**PARK CITY MUNICIPAL CORPORATION
BOARD OF ADJUSTMENT
COUNCIL CHAMBERS, CITY HALL
October 18, 2016**

638 Park Avenue Avenue – Appeal of Staff's Approval of a Historic District
Design Review for the Historic Kimball Garage
Quasi-Judicial hearing and continuation to October 18, 2016

Subject: 638 Park Avenue (Kimball Garage)
Author: Anya Grahn, Historic Preservation Planner
Date: October 18, 2016
Application: PL-16-03225
Type of Item: Quasi-Judicial – Appeal of Staff’s Determination of Compliance with the Design Guidelines for Historic Districts and Historic Sites

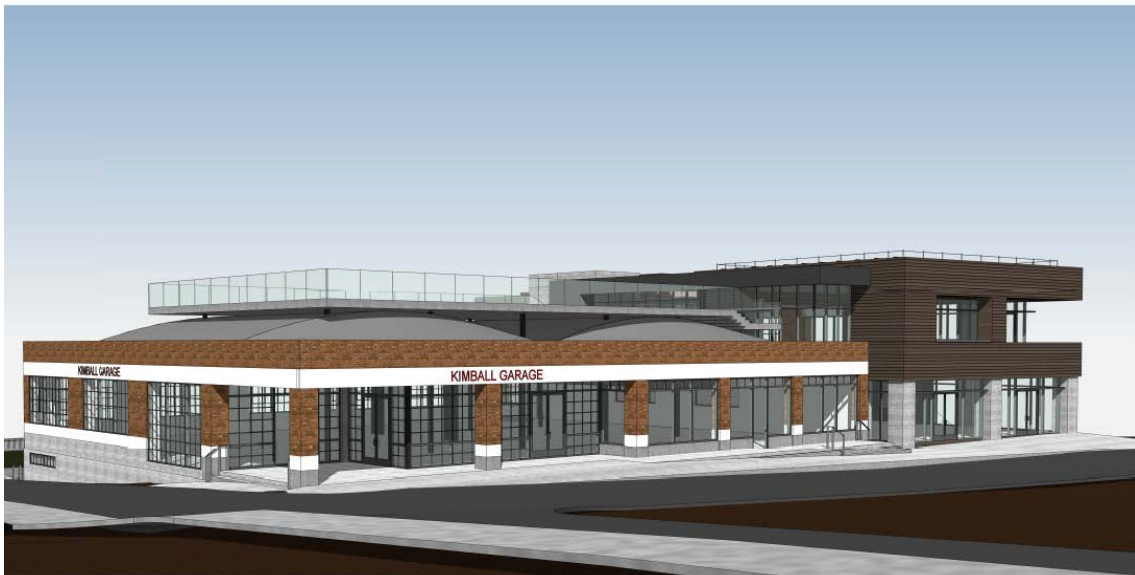
The appellant also argues that the rooftop deck addition as proposed will dramatically alter the appearance of the Landmark Structure as the new deck will destroy and replace half of the double barrel-vaulted roof. Adding a balcony from the adjacent new building and extending over the historic building will change and diminish the character of the Kimball Garage and change the essential form of the

Finally, the increased elevation of the deck would not have aligned with the third floor of the new addition which would have made it appear tacked on to the new addition and would have detracted from the cohesive appearance of both the historic structure and the new addition. Staff and the applicant found that a cantilevered deck would have had a greater negative impact to the historic integrity of the structure than the removal of the barrel-vault in order to accommodate the rooftop deck; in fact, the proposal of a cantilevered rooftop deck above the barrel-vault would have been denied outright (Figure 8).

Staff finds that rooftop additions, such as the proposed rooftop deck, are permitted by the Design Guidelines. The new deck addition will only impact the eastern barrel-vaulted roof form and will be setback from the Heber Avenue façade of the building in order to minimize the visibility of the necessary railing from street view. Further, the western barrel-vault will be retained in order to preserve the historic roof form and also provide some shielding of the rooftop deck from uphill viewpoints. The patio does not exceed one story in height, and in fact its impact is further minimized by the removal of the barrel vault, which allows the deck to sit lower and be masked by the historic parapet.

Figure 9. Present location of doors on Heber Avenue façade.

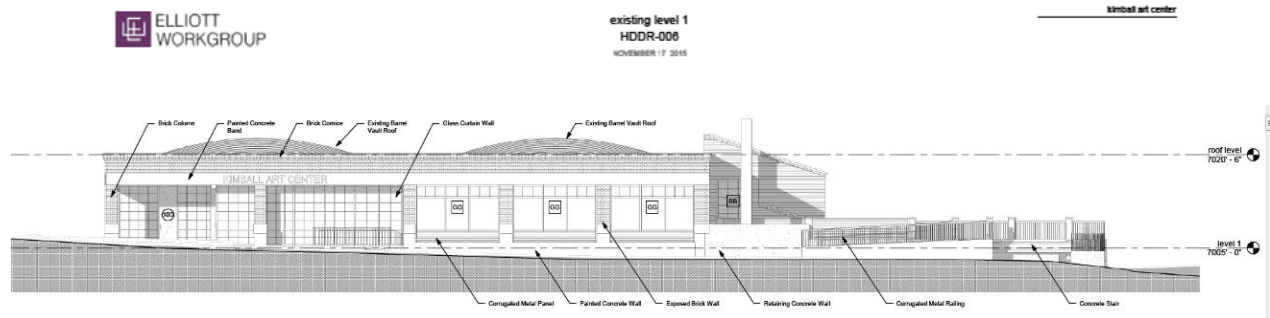
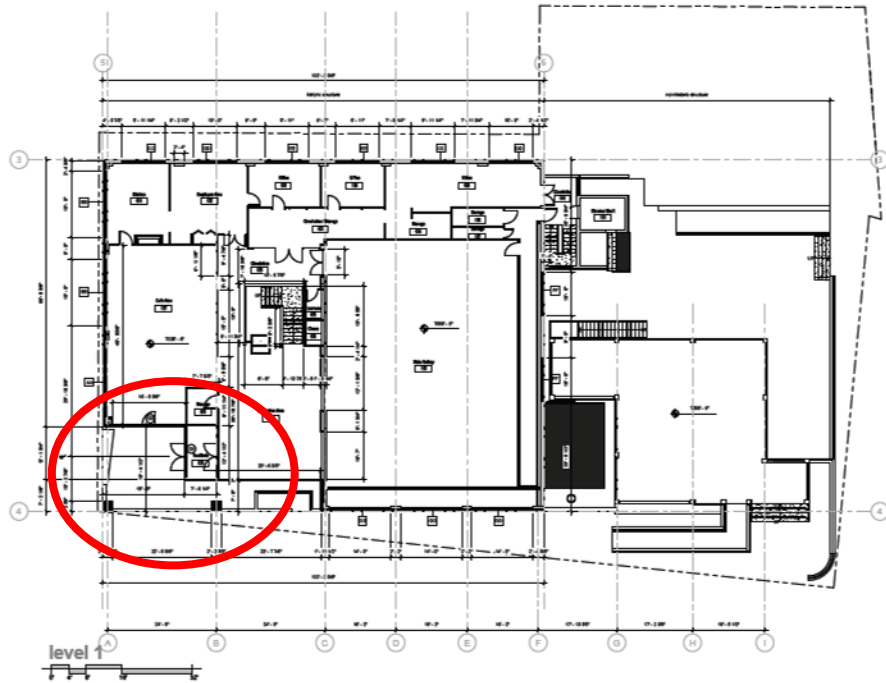
The Park City Historical Society & Museum contests that the addition of a new door or opening on the front (Heber Avenue) façade does not meet the LMC or the Historic District Design Guidelines.

As existing, the entrances to the Kimball Garage are on the recessed southwest corner of the building beneath the overhang (Figure 9). There is one door on the south façade, facing Heber Avenue, and a second double-door entrance on the west façade, facing Park Avenue. These two entrances are both located on the non-historic ca.1976 divided-light glass addition beneath the historic overhang. On the façade, facing Heber Avenue, the three eastern bays consist of windows.

Figure 10. Proposed location of double-doors beneath recessed southwest corner and single door on principal Heber Avenue façade.

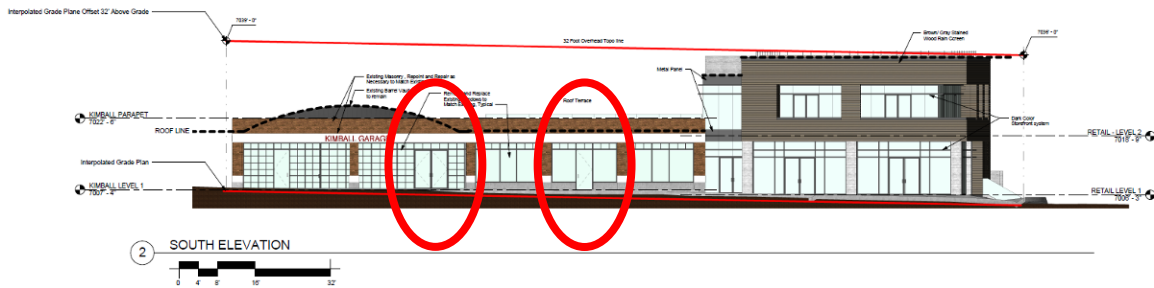
The applicant is proposing to relocate the double-entry doors on the west side of the ca.1976 addition to the Heber Avenue façade. They are also proposing to construct a single door on the fourth bay of the historic Heber Avenue façade that will provide an additional entrance (Figure 10). This entrance is necessary to access Retail Space #6.

Staff finds that there was a door in the fourth bay from the west since at least ca.1930, and that it was almost certainly original to the 1929 building (Figure 11). In the Pop Jenks ca.1930 photograph, although the door is partially obscured by a parked car, the top of the single-light door and a transom above it are clearly visible. The same door and transom are visible in the ca.1949 photograph, although by this time all of the transom windows had been painted white or boarded over, probably due to excess heat gain on this south exposure. It is likely that the door led to a retail area of the sales office, service area, and/or restrooms of the garage. Universal Guideline #4 encourages owners to reproduce missing historic elements that have been lost, such as this original door opening, based on photographic evidence. The applicant's intent to restore this door opening complies with Universal Guideline #4 as well as Specific Guidelines B.2.1, B.4.1, and B.5.1 that seek to maintain primary façade components, historic door openings, and the traditional orientation of primary entrances of commercial facades.

Figure 17. Proposed changes to windows and window openings on north side of the building.

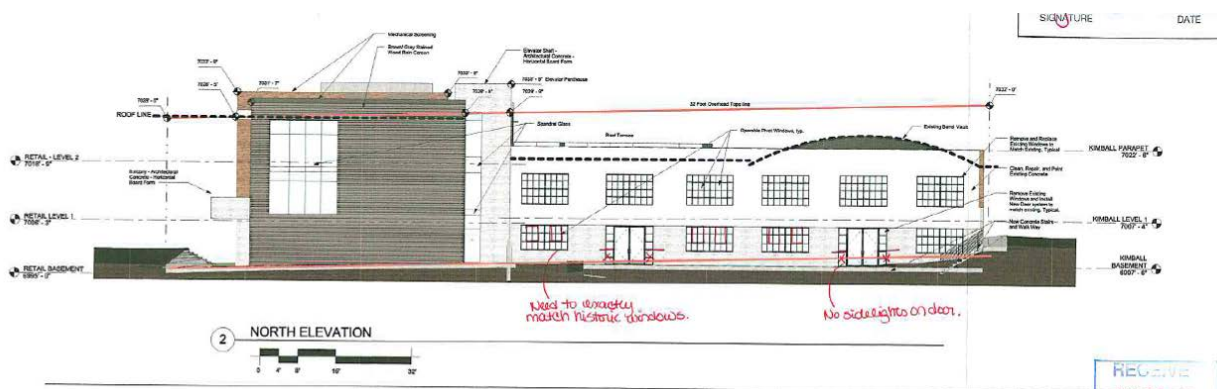
The applicant is proposing to convert two of the six lower level windows to doors on the north (rear) elevation (Figure 17). Staff has redlined the plans to allow only the double-door opening in the center of the window, but to incorporated shorter sidelights so as to maintain the line created by the height of the windows above grade. Additionally, this will have a minimal change to the configuration of window to door openings on the rear face. Given that the rear façade is in an inconspicuous location and is largely not visible from the public right-of-way along Park Avenue, staff found that there was greater flexibility in allowing changes to the windows on the rear façade.

Figure 18. Chronology of changes to the Park Avenue façade.

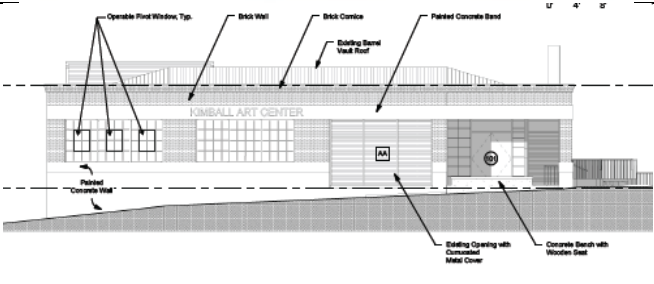
Further, the appellant argues that this it is not appropriate to replace the non-historic corrugated metal, boarded window opening along Park Avenue with a new window as there is no evidence for the substitution.

Staff finds that the second bay from the south was enclosed early on as the height of Park Avenue was altered and made it impossible for automobiles to enter this bay into the fuelling station. The opening was further filled in during the 1976 renovation, but the opening was restored as part of the 1999 renovation. Corrugated metal was used to fill

this window opening in 1999, which once served as an automobile entrance to the fueling station from Park Avenue. The applicant is proposing to retain the existing opening, but replace the corrugated metal panel with a new window. The opening abuts interior space and staff finds the window will promote the transparency of this opening (Figure 18).

1 EAST ELEVATION

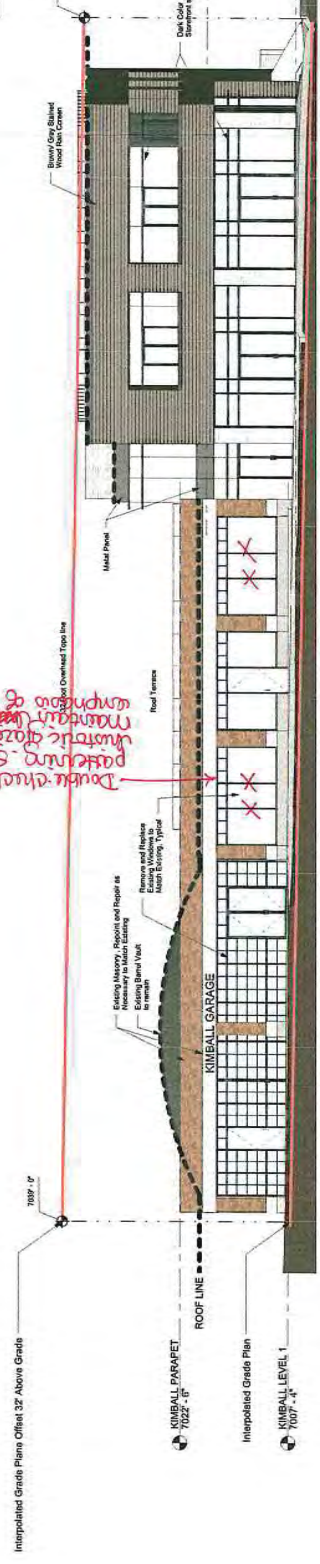
Double check window patterns - should match pattern. Glazing pattern to maintain horizontal emphasis of bldg.
